**Project #19-011  
L.W.'s Car Wash  
Located at 975 W 200 N**

**REPORT SUMMARY...**

<i>Project Name:</i>	L.W.'s Car Wash
<i>Proponent / Owner:</i>	Brent Miller / Larsen Miller LLC
<i>Project Address:</i>	975 W 200 N
<i>Request:</i>	Design Review Permit
<i>Current Zoning:</i>	Commercial (COM)
<i>Type of Action:</i>	Quasi-Judicial
<i>Hearing Date</i>	April 11, 2019
<i>Submitted By:</i>	Aaron Smith, Planner II

**C1 SOUTH ELEVATION**  
AS NOTED

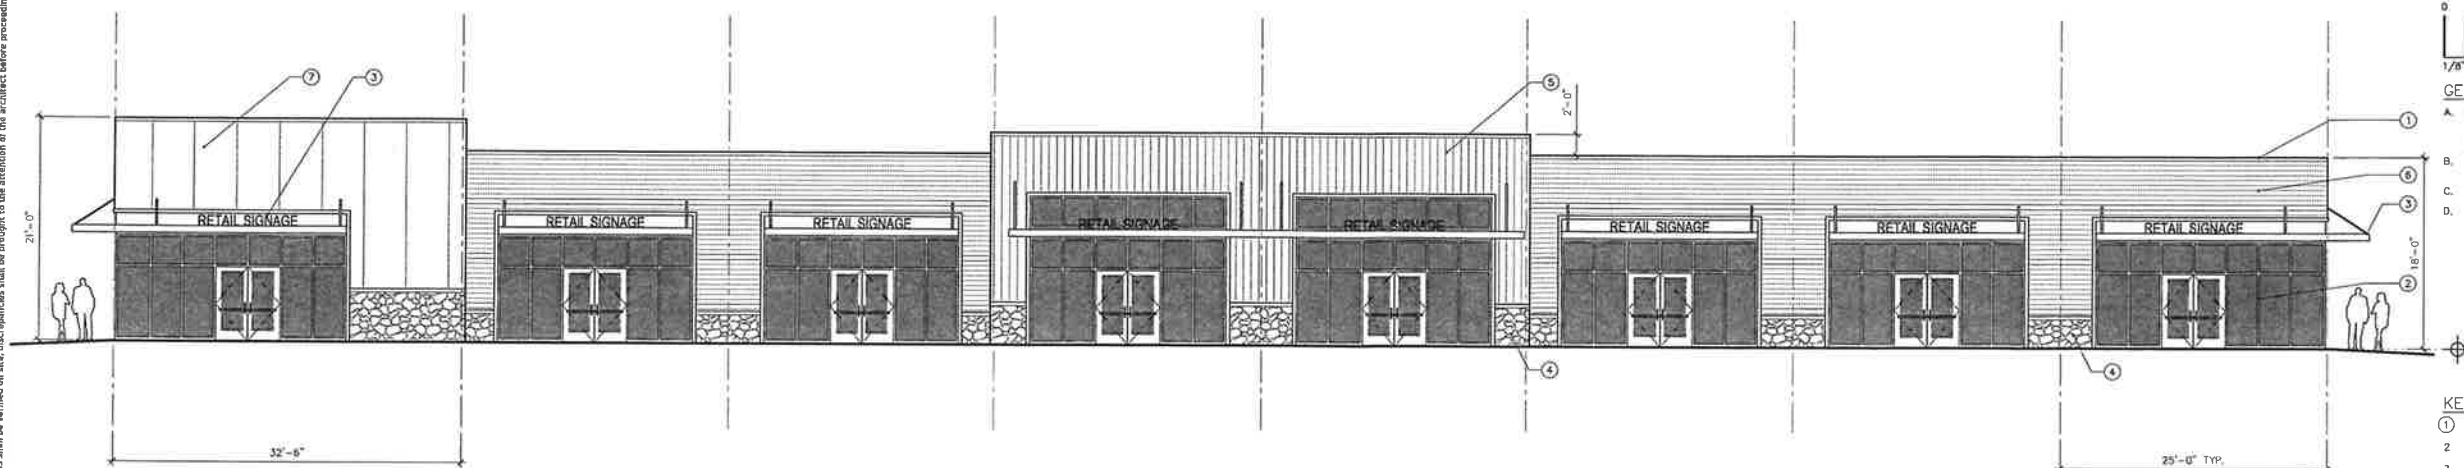
Commercial Building	
West Elevation (1000 W Frontage):	34%
East Elevation:	45%
South Elevation (200 N Exposed side):	20%
North Elevation:	20%

The proposed transparency of the south facades on both the commercial building and carwash do not meet the transparency requirements for the commercial zone. As conditioned, requiring

12. The south elevation of the commercial building shall have a minimum transparency of 30%.
13. Any dumpsters near the street shall be visually screened or buffered with landscaping and/or fencing.

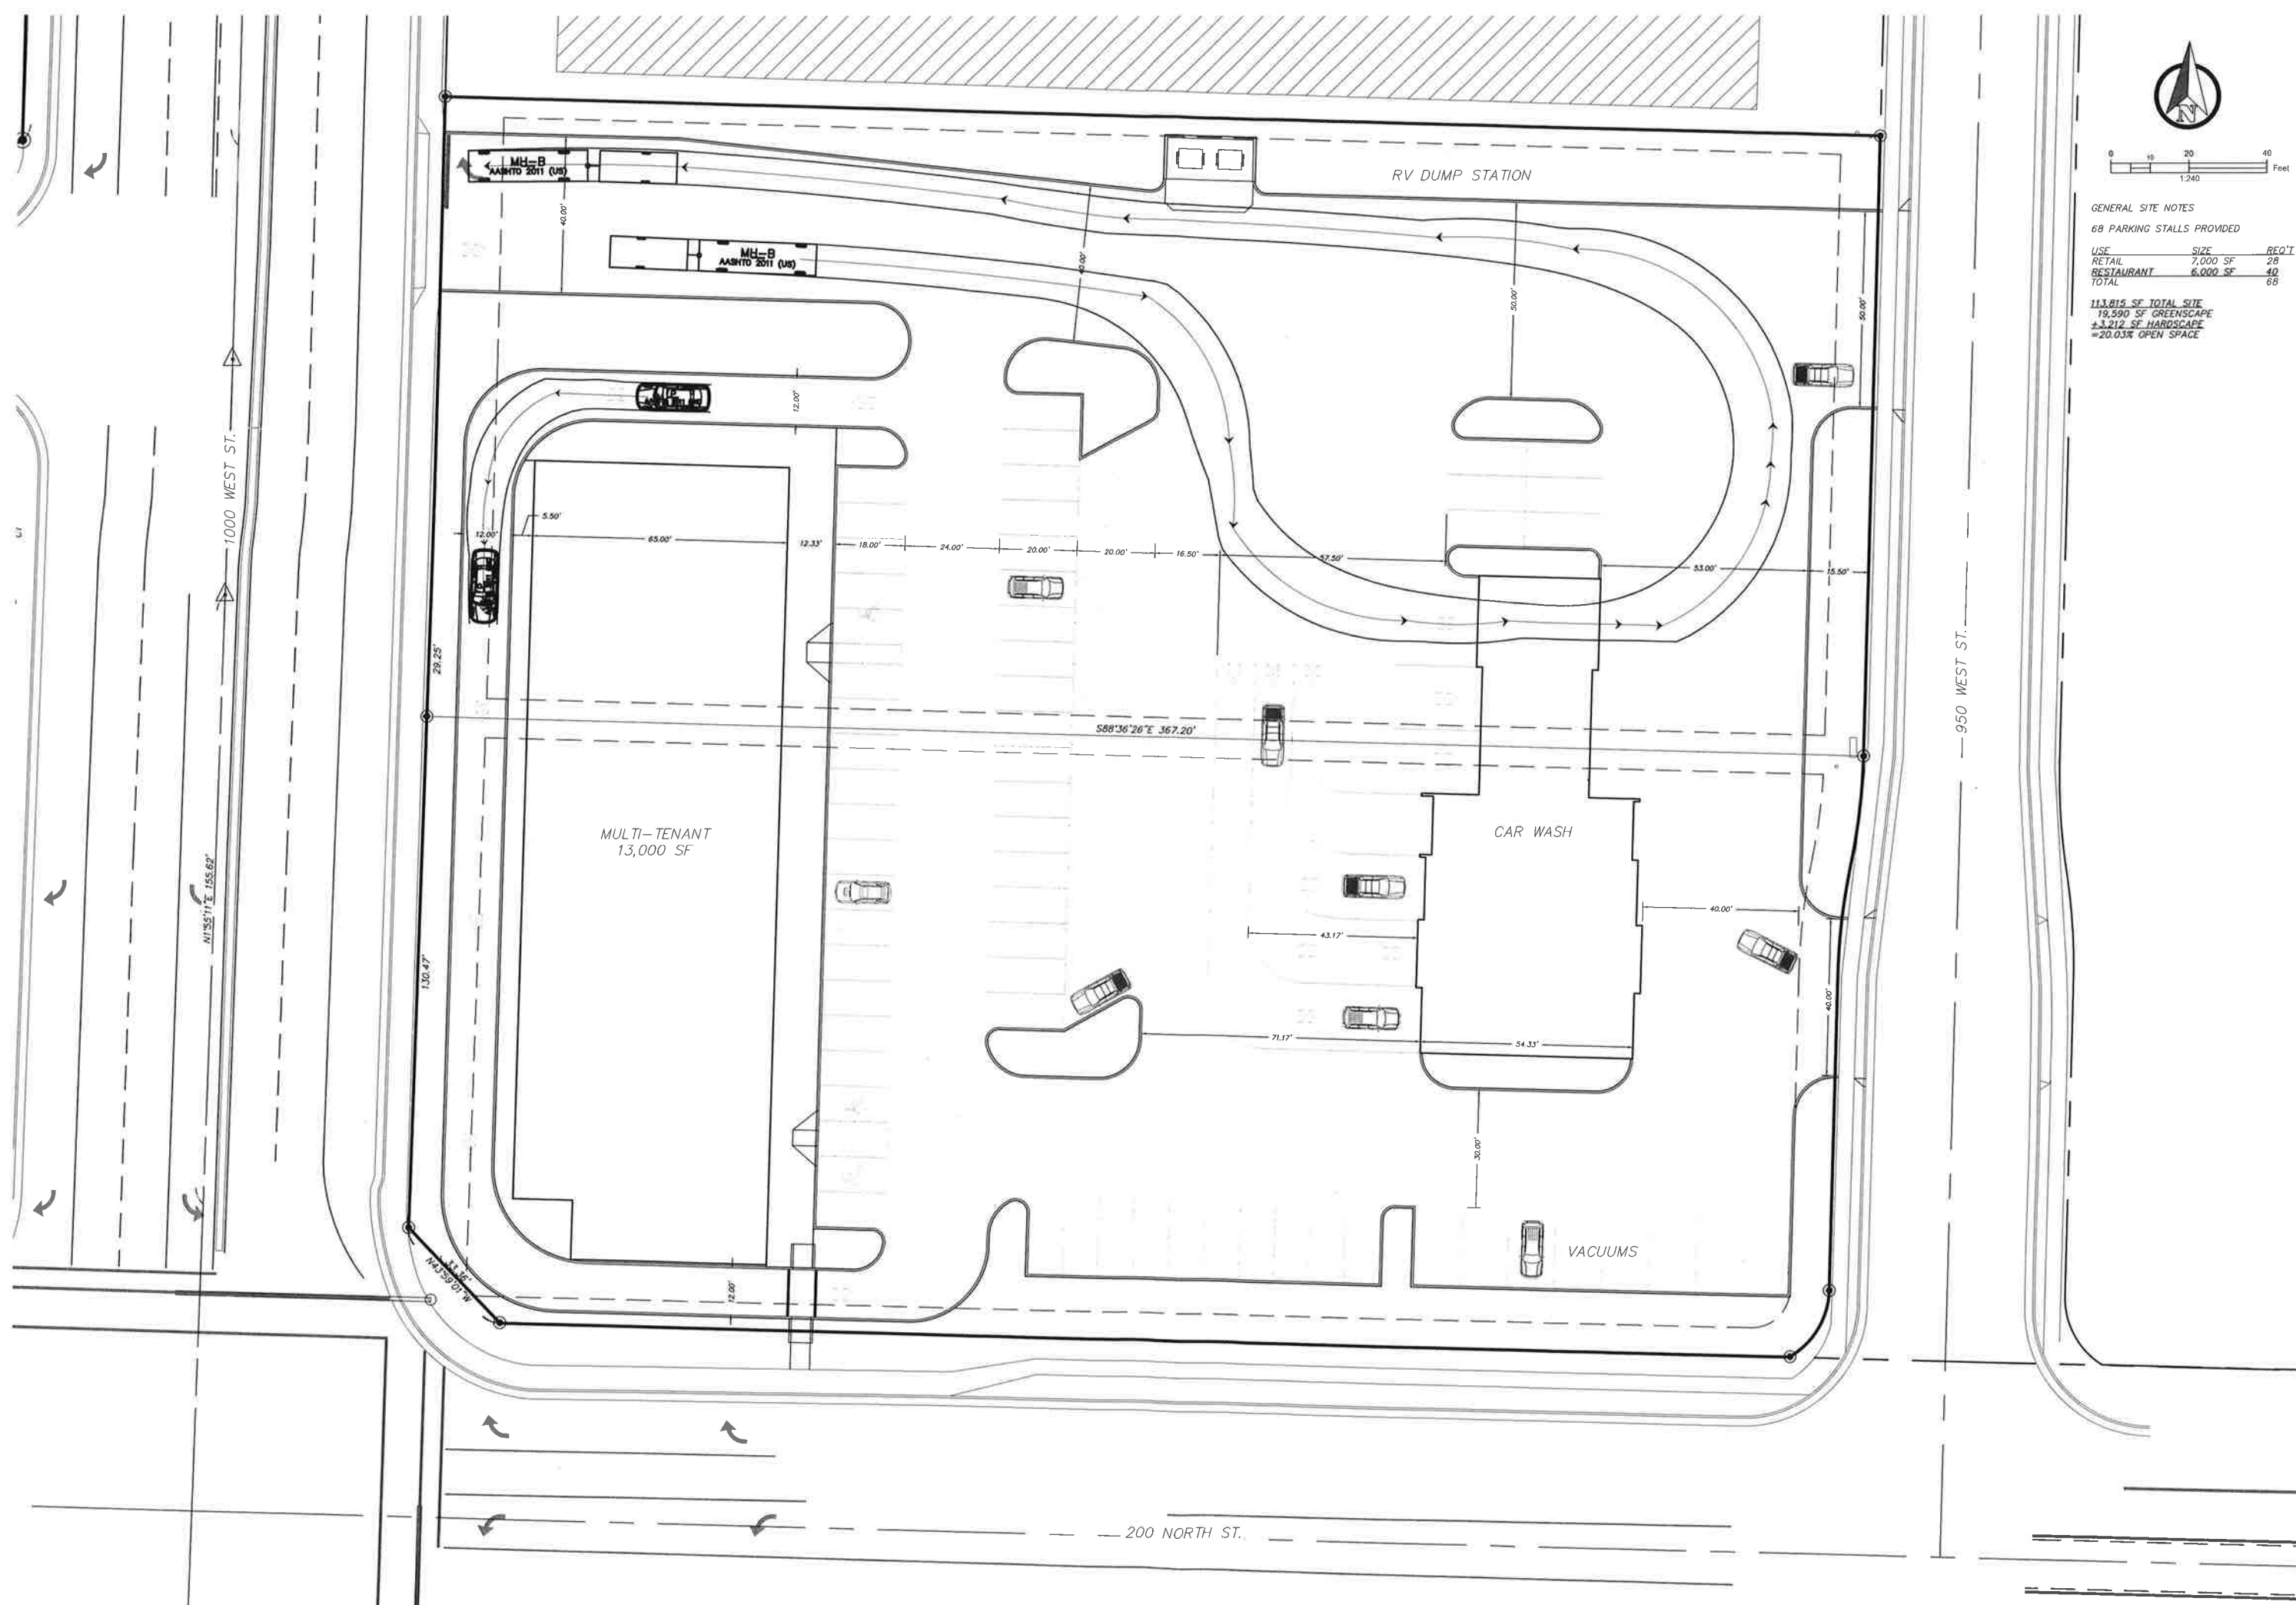
Vehicular driveway access is proposed on 1000 W and 950 W. The access along 1000 W is limited to right-in and right-out vehicle movements due to the center median. Two accesses are proposed along 950 W. The project proposes a pedestrian access point from the commercial building to 200 N, but does not propose a pedestrian access to 1000 W. The nature and use of a carwash does not warrant pathway connections. As conditioned, with pedestrian pathways connecting from the commercial building to 1000 W, the project complies with the requirements in the LDC.

An area of concern in regard to parking is the proposed parking and vacuum stations south of the carwash. No parking is allowed in the front yard without a Conditional Use Permit in the Commercial zone. In this instance, staff considers the vacuum station area to be a dedicated vehicle service use and not parking. The parking southwest of the carwash may be considered in the front yard of the carwash, however, the parking is located behind the south plane of the commercial building and could be considered in the side yard once the commercial building is constructed during phase 2. As conditioned, the project complies with the requirements in the LDC.

3. Provide a pedestrian pathway that connects the commercial building to 1000 W.
4. A minimum of 52 parking stalls, 8 stacking positions within the drive-through lane and a bike rack shall all be provided for the commercial building.

5. A minimum of 1 stacking space for self-serve bays and 6 stacking spaces for auto wash bays shall be provided for the carwash.
6. All parking along 200 N should be constructed during phase two and placed in the side yard of the commercial building.

7. A landscaping buffer will be constructed between the parking and the sidewalk along 200 N. The buffer shall conform with Type "B" Separations, LDC 17.32.070.B.

A1 SOUTH ELEVATION  
AS NOTED

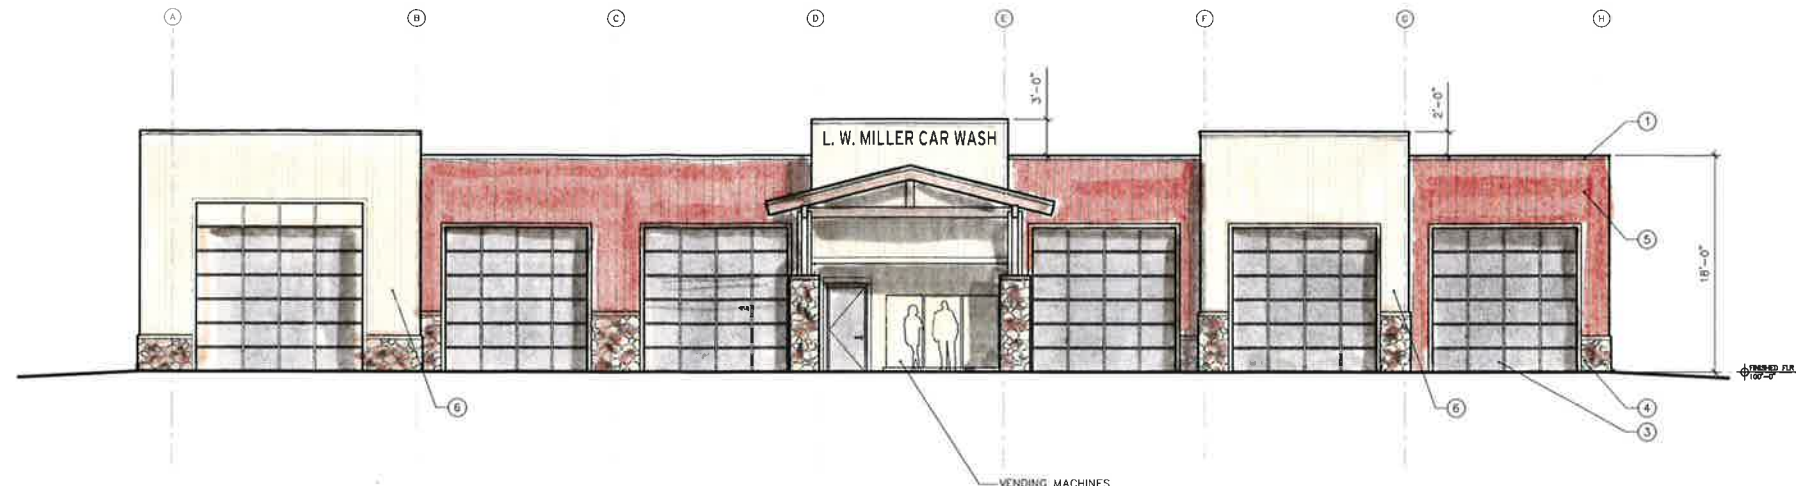
The buildings have clear horizontal articulation and massing with changes in material, rooflines, and projections that divide up both the commercial building and carwash facades. One area that does not meet the articulation requirement is the south façade of the carwash. This façade will require additional articulation to break the wall plane. As conditioned, the project complies with the requirements in the LDC.

Carwash	
West Elevation:	45%
East Elevation:	45%
South Elevation (200 N Frontage):	0%
North Elevation:	0%

10. The south elevation of the carwash shall have horizontal articulation that meets the requirements of §17.12.020.4.a.
11. The south elevation of the carwash shall have minimum transparency of 30%.
